SCHEME RANKING

APS: New Elementary School at Reed

BLPC + PFRC

Rank from 1 (Favorite) to 6 (Least Favorite)

Upper Lower Scheme

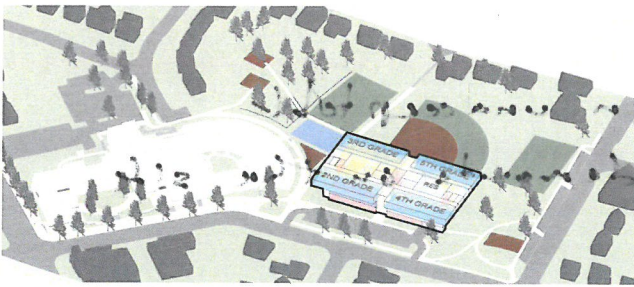
Better than standalone, but only by a bit

Standalone Scheme

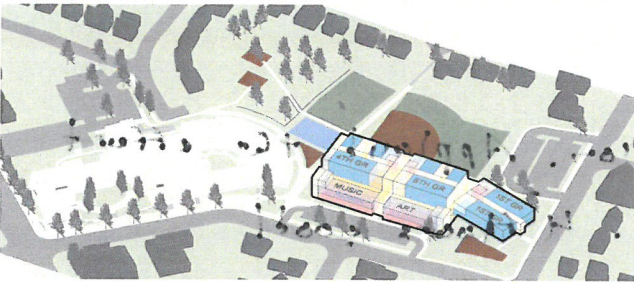
This is just an unacceptable escalation of the demands on the site

Integrated Scheme

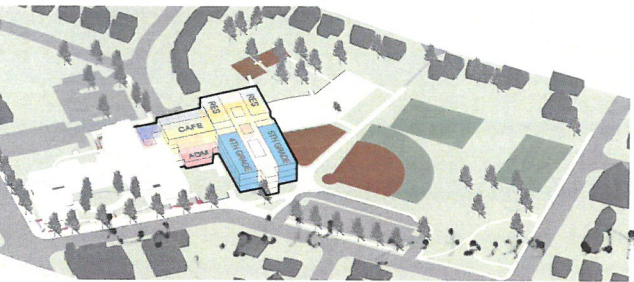
This is the best option. Applaud the effort to ease the massing. 4 floors good

Bridge Scheme

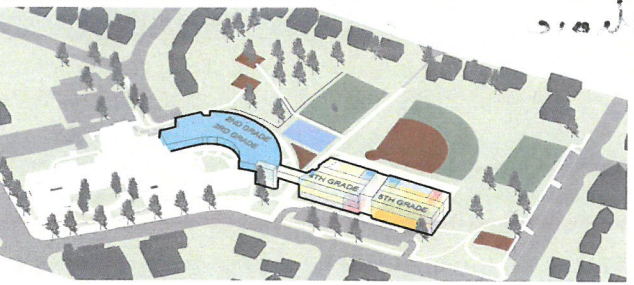
Not crazy about the existing bldg., but this is a rational choice

Standalone Scheme

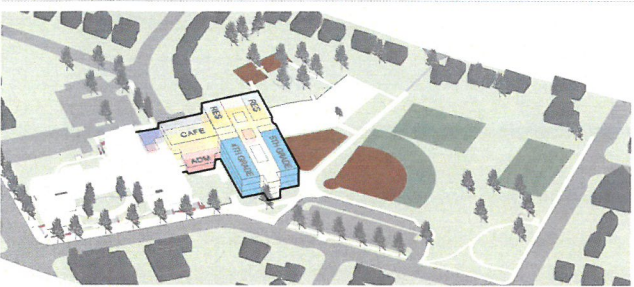
Standalone is too destructive to the community.

Integrated Scheme

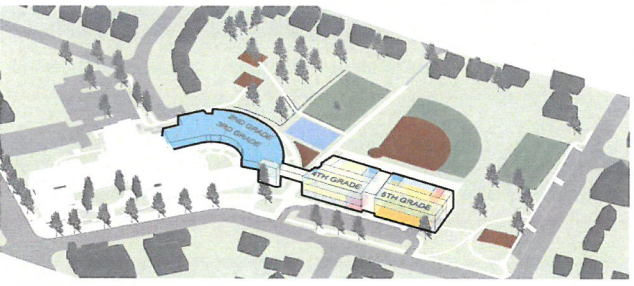
Integrated: meets the seat requirement
preserves valuable play, / green / open space

Standalone Scheme

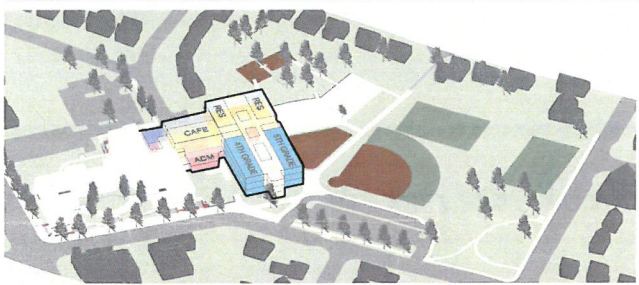
non-starter -> no community support

Integrated Scheme

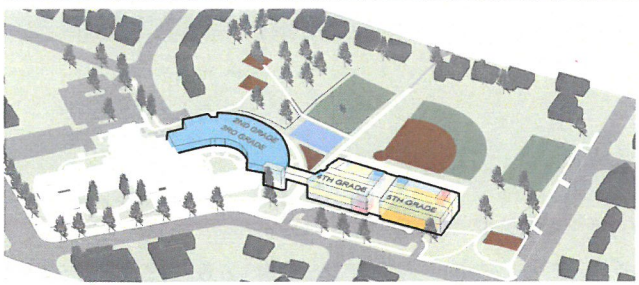
Clear consensus on this from public, cmte + educators

Integrated - Best Because

- Respects the committee process + feedback
 - Meets all aspects of original charter
 - Supports PFRC feedback on green space, concurrent field play, multi-use facility
 - civic design principles
 - Best for learners - Educator preferred
 - Clear community favorite
- 725
- under \$49M
- etc.
- optimal work environment (per teachers)
